Architectural Review Board Agenda
4:00 PM Wednesday, JUNE 5, 2024
Sussex Civic Center – Committee Room Second Floor

TO: Architectural Review Board
FROM: Gabriel Gilbertson, Community Development Director
RE: June 5, 2024 Architectural Review Board
DATE: Friday, May 31, 2024

- I. **Roll call.**
- II. **Consideration and possible action on the ARB minutes of April 3, 2024.**
- III. **Discussion and possible action on site plan, landscape plan, architecture plan, and lighting plan for Highlands Business Park Site XII.**

IV. Consideration and possible action on the site plan, architectural plan, lighting plan, landscape plan for Club Carwash located at W248N5221 Executive Dr in the B-3 Highway Business Zoning District.

1 | ENLARGED PLAN - DUMPSTER ENCLOSURE
1/4" = 1'-0"

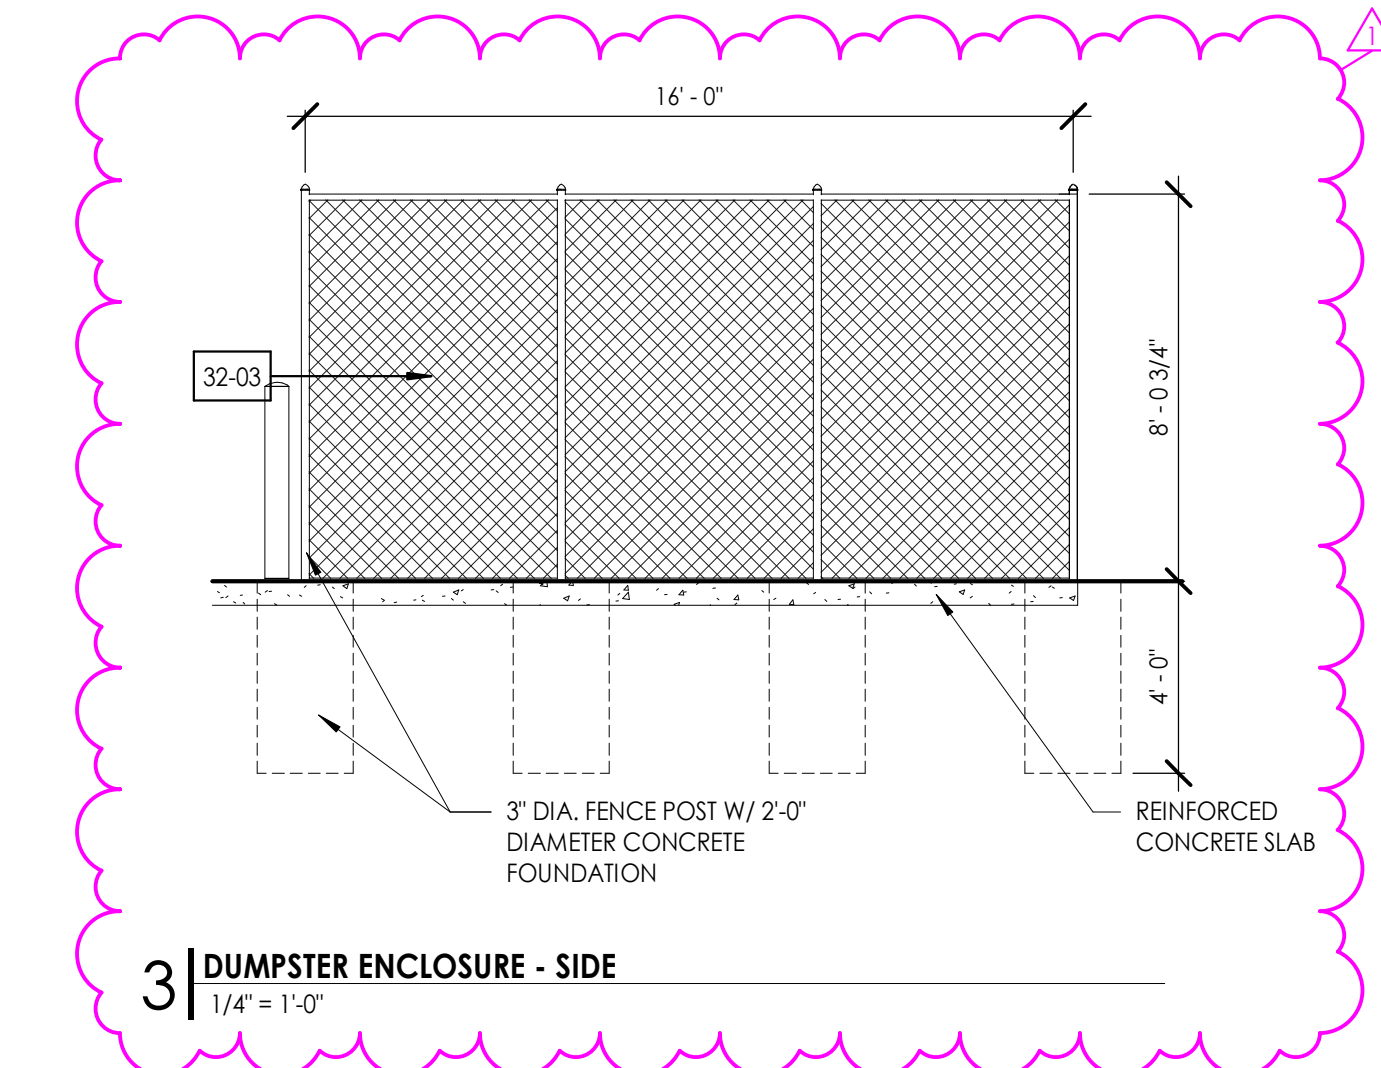
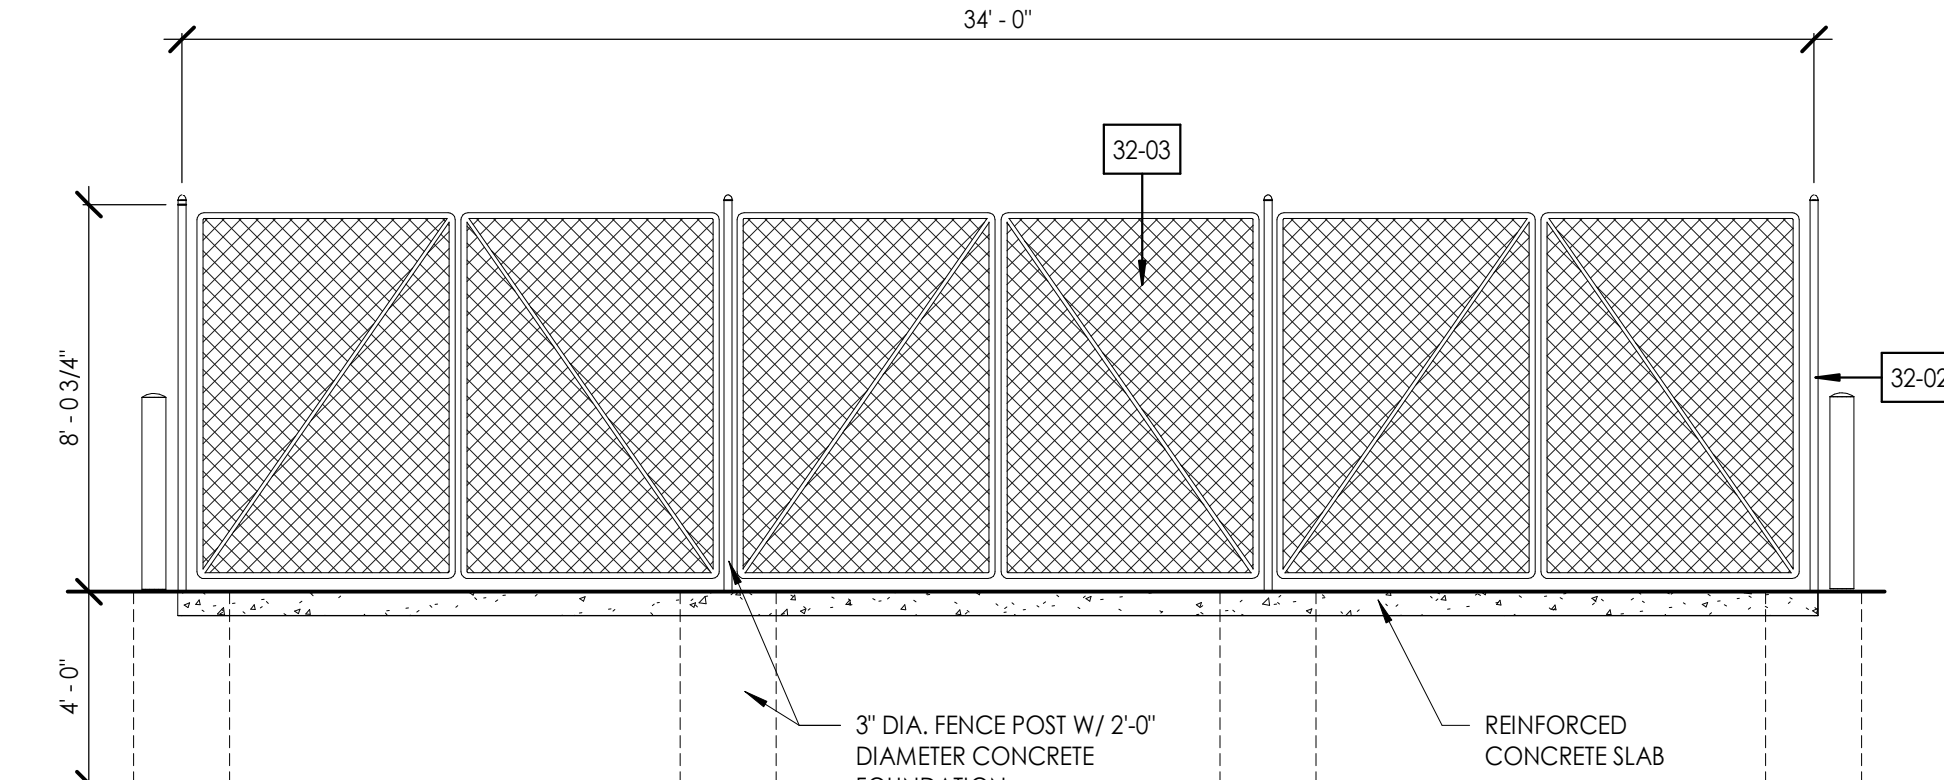
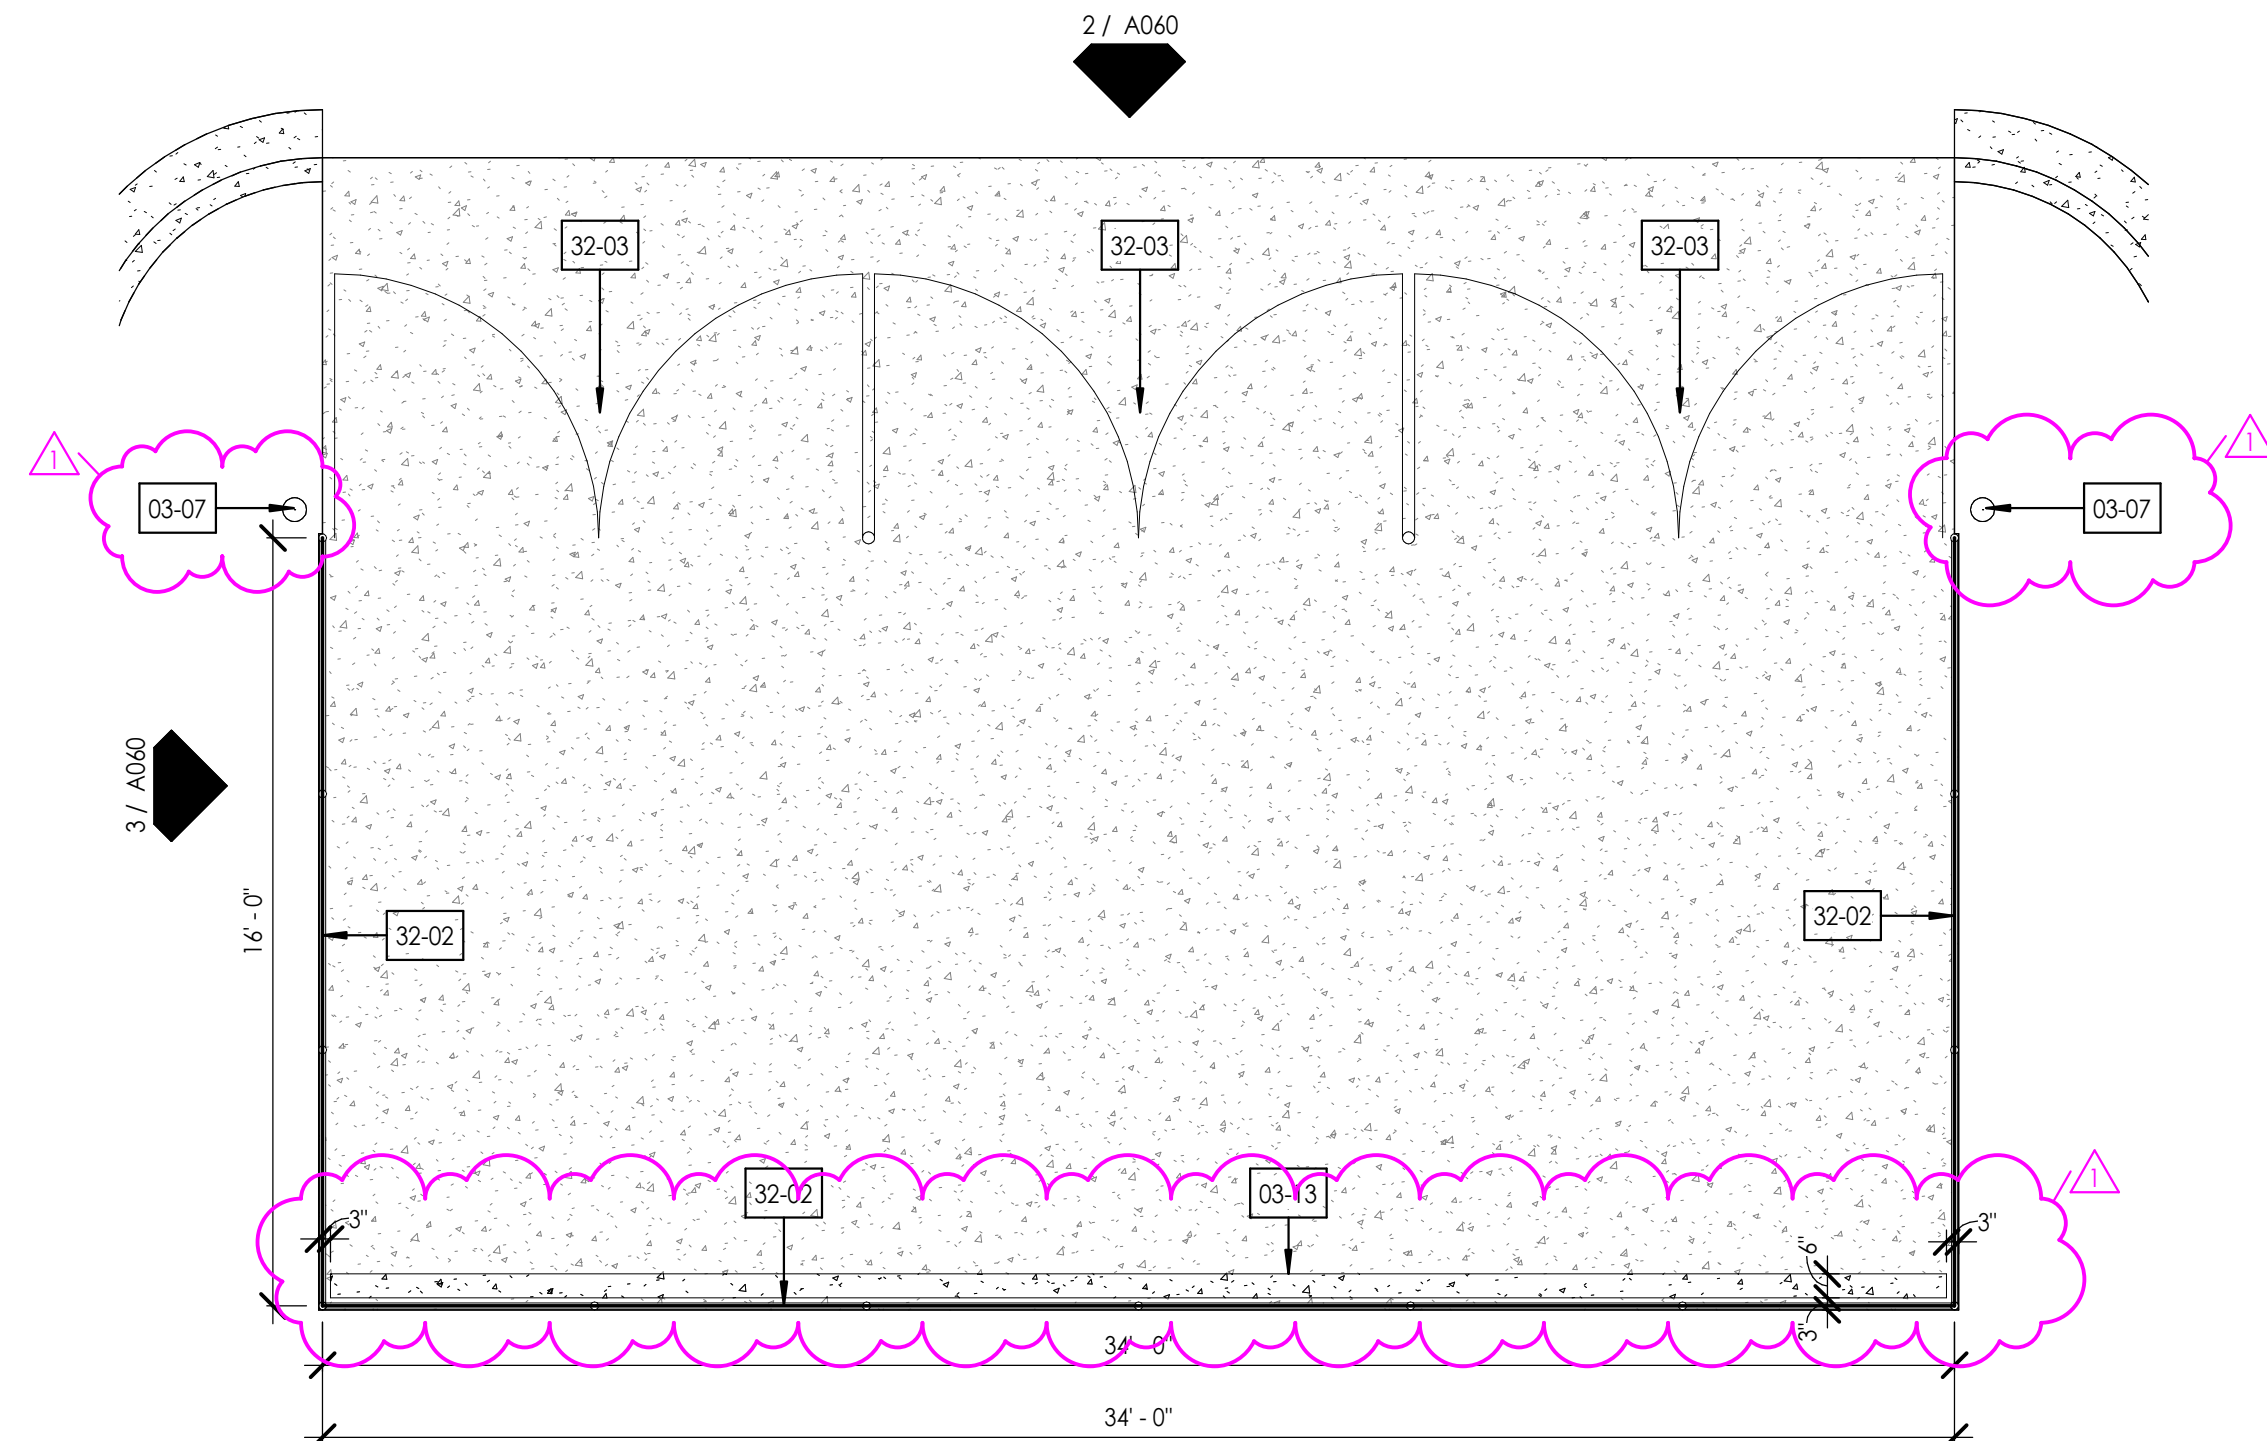
- The proposed dumpster enclosure is chain-link fence and needs to be constructed of similar materials or architecturally match the principal building. Revised elevations of the enclosure is needed.

1. Submit revised plans for the dumpster enclosure that meet the requirements of the design guidelines to Staff for review.
2. Submit revised landscape plan that meets the minimum shrub requirements to Staff for review.
3. Submit details on how the proposed light poles will be installed for Staff to review.
4. Include a note on the elevations that with the percentage of window/door openings for each elevation to Staff for review.

BUILDING ELEVATIONS

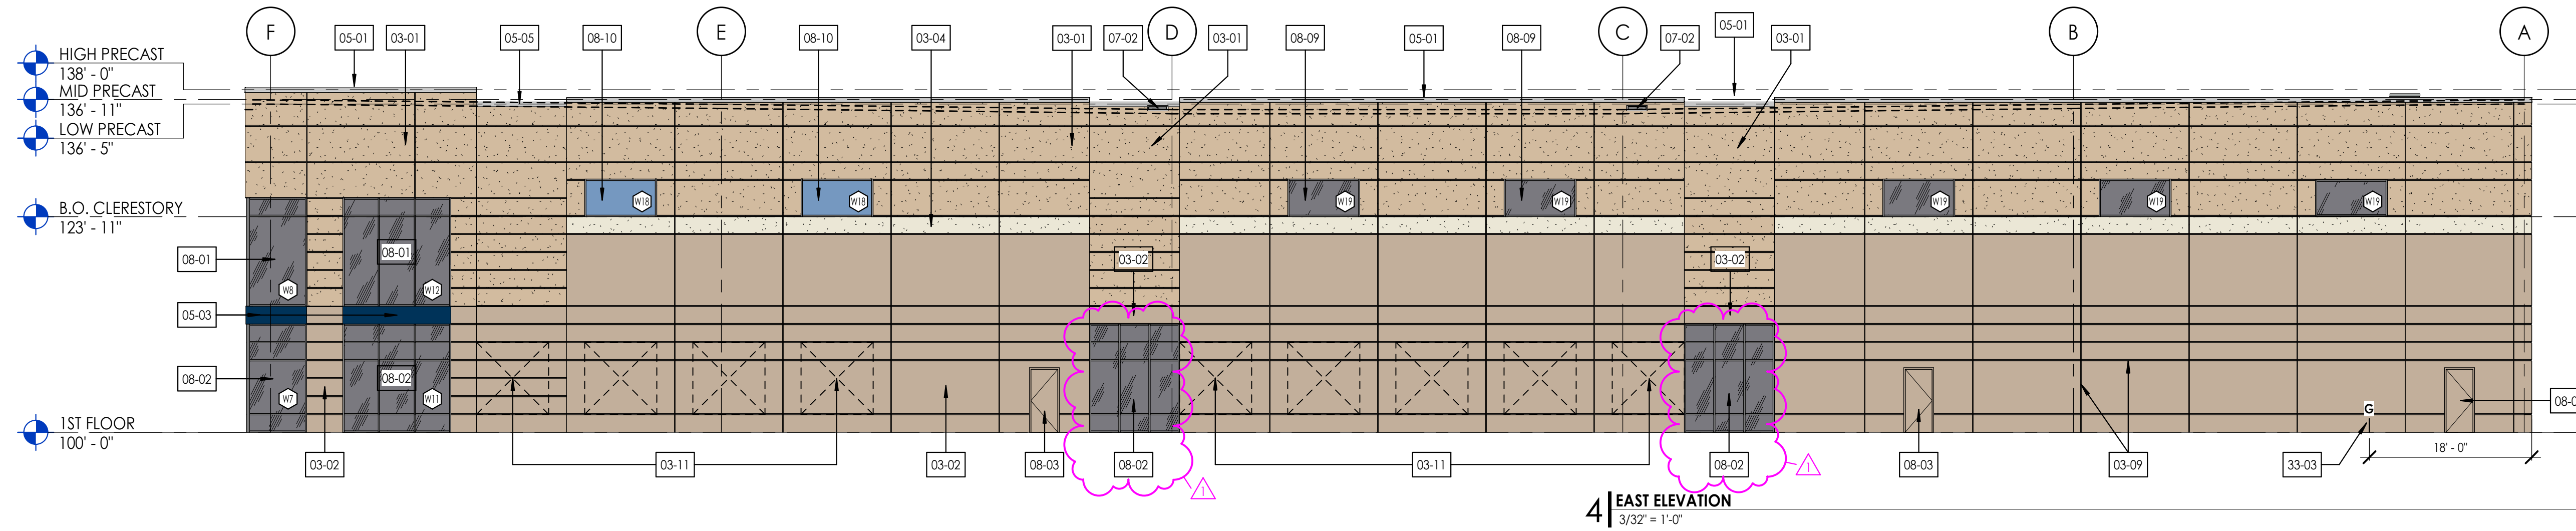
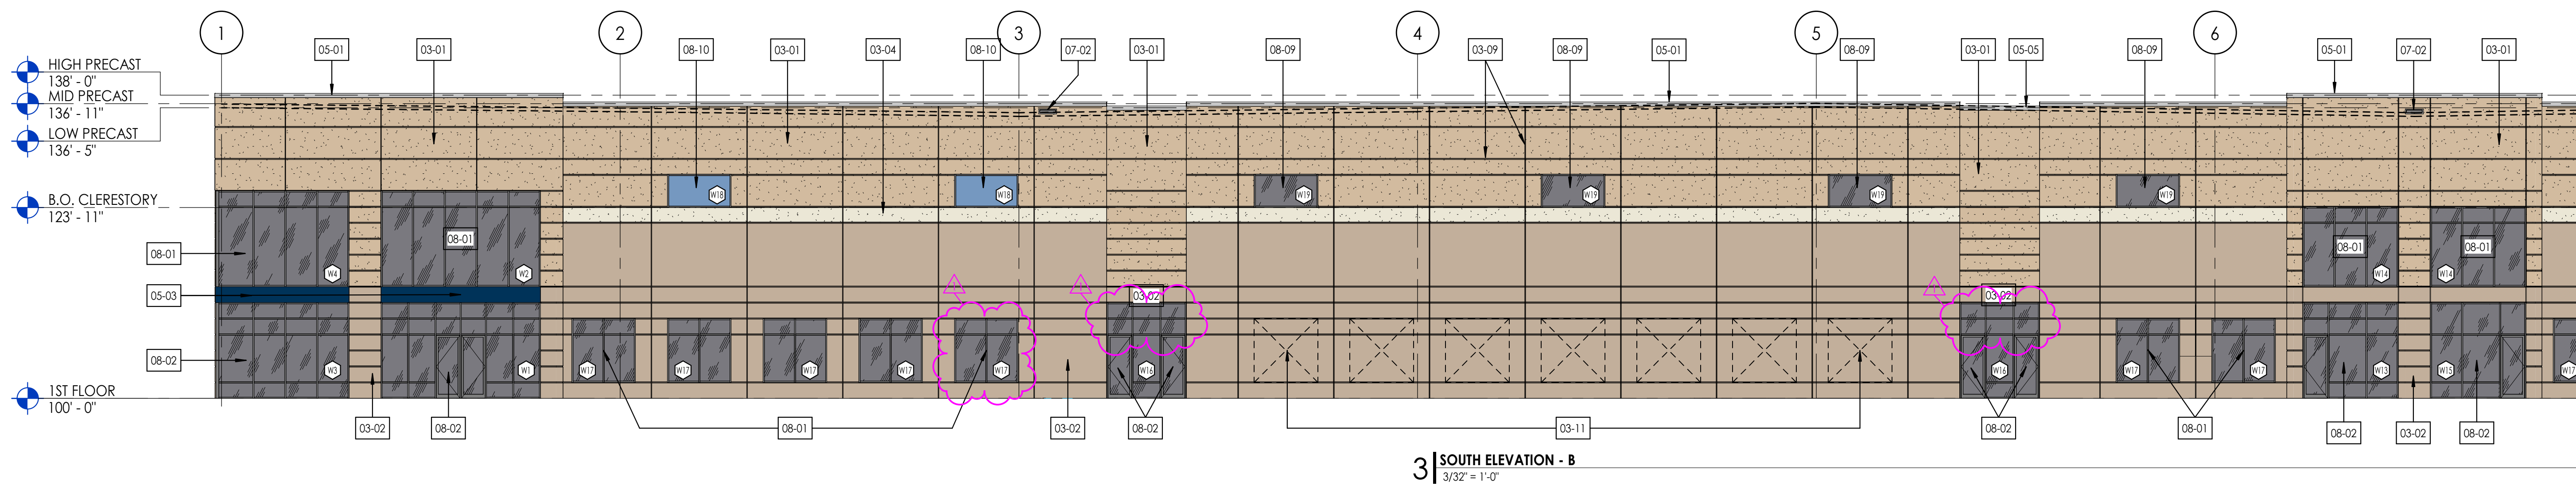
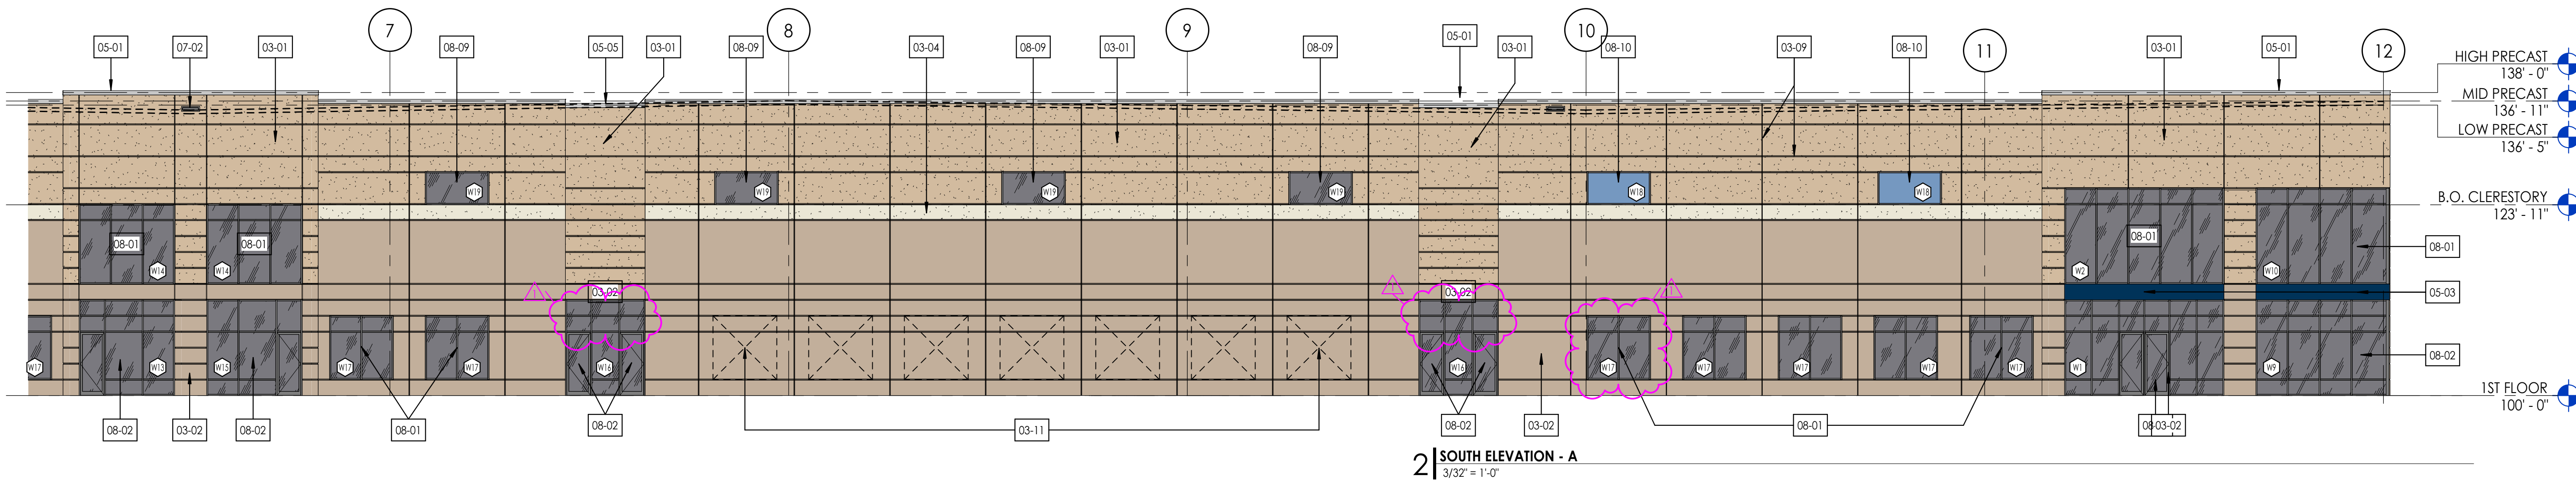
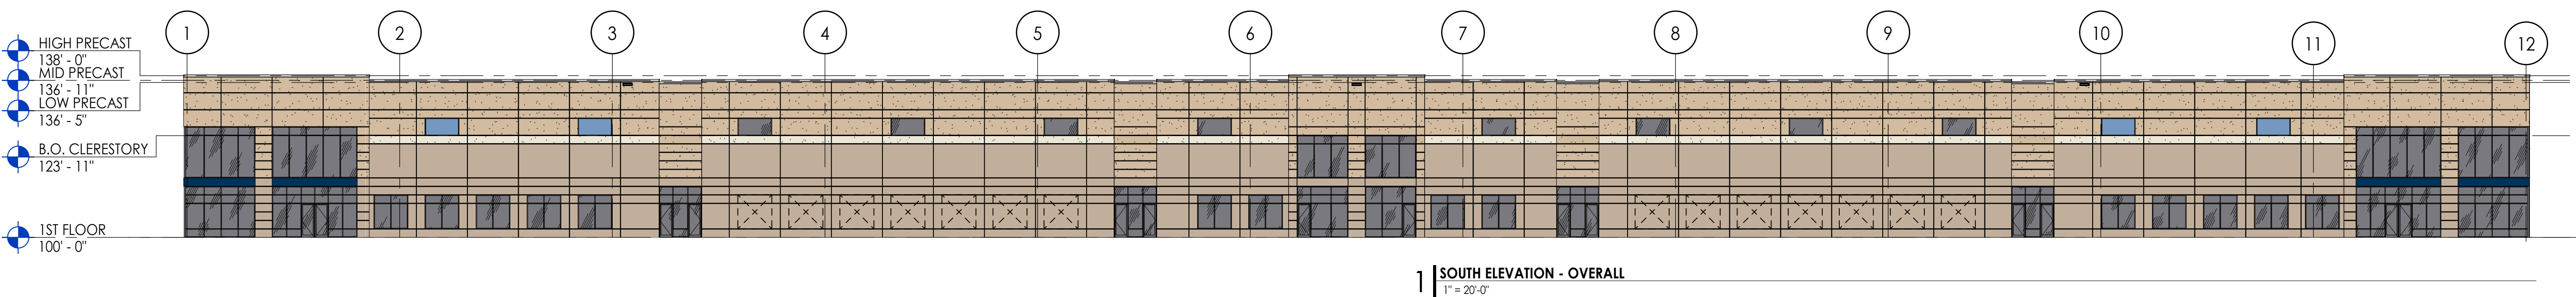
- Building meets height and required setbacks.
- Location of any RTU's are not known at this time. When their locations are known, a plan shall be submitted to staff that includes the type of screening that will be used.
- Material to be used meets the Design Standards.
- Windows are included on each elevation. Percentage of window and door openings needed for the front (south) elevation. The applicant stated that additional glazing has been added to achieve the minimum 20% required for window and door openings, but a note should be made on the plans that includes that information.
